SCHWEIZER SERVICE NOTICE

NOTICE NO. N-212

DATE: 10 March 1988

SUBJECT: ONE-TIME X-RAY INSPECTION OF TAIL ROTOR BLADE SPAR (PN 269A6035-21 AND -23).

FIGURE 1. X-RAY INSPECTION OF TAIL ROTOR BLADE SPAR

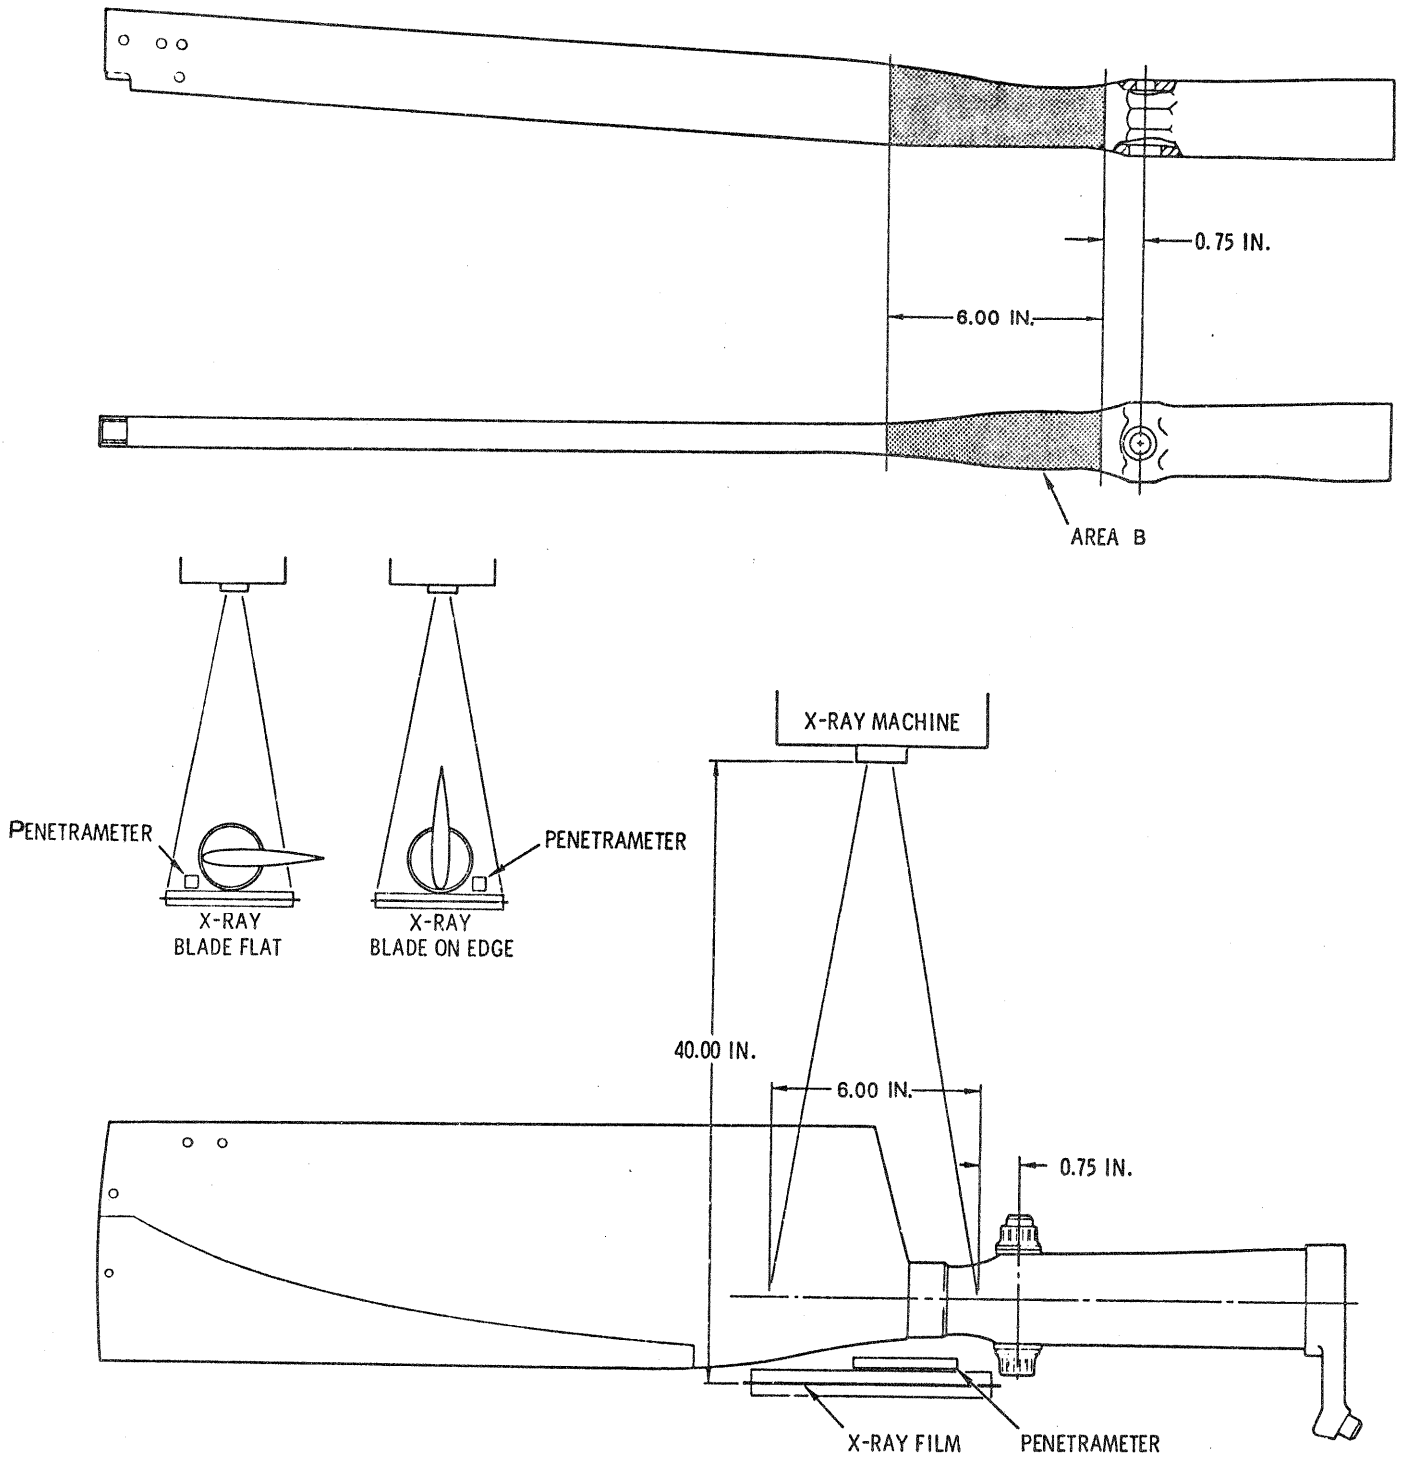
- a. Perform preliminary procedure (HMI Appendix C, Part VII, para. 3-9).
- b. Perform periodic visual inspection of tail rotor blade spar (HMI Appendix C, Part VII, para. 3-10). Be sure to remove all loose scale and corrosion as specified in paragraph 3-10.
- c. X-ray each affected tail rotor blade in area from 0.75 inch to 6.75 inches outboard of blade retention bolt centerline (AREA B) as shown in Figure 1. Take x-rays in accordance with the referenced HMI Appendix C, Part VII, Paragraph 3-12.
- d. If any indication of pitting is visible in x-ray, inspect spar interior with a borescope to verify that all pits are on the interior surface of the blade spar.

IN ALL CASES WHERE THE BLADE'S X-RAY INSPECTION REVEALS INDICATION(S) OF PITTING IN THE INSPECTION AREA (FIGURE 1, AREA B), MAKE A COMPARISON BETWEEN THE X-RAY PATTERN AND THE INTERIOR PATTERN. IF PATTERNS DO NOT MATCH EXACTLY, THE BLADE MUST BE RETIRED FROM SERVICE BECAUSE IT INDICATES EXTERNAL CORROSION.

- f. If spar is free of external corrosion in Area B, perform casting procedure to determine depth of corrosion pits. (Refer to HMI Appendix C, Part VII, Paragraph 3-11.)

FIGURE 2. TAIL ROTOR BLADE IDENTIFICATION PLATE

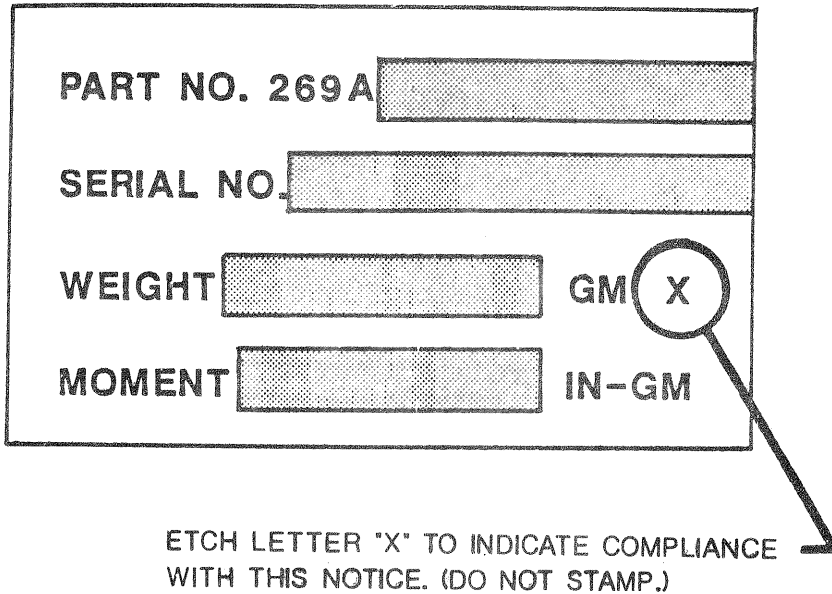
- (1) Add letter "X" below the serial number and adjacent to the "GM" symbol on the blade ID plate to indicate compliance with this notice; use electric pencil or equivalent. (Refer to Figure 2.)
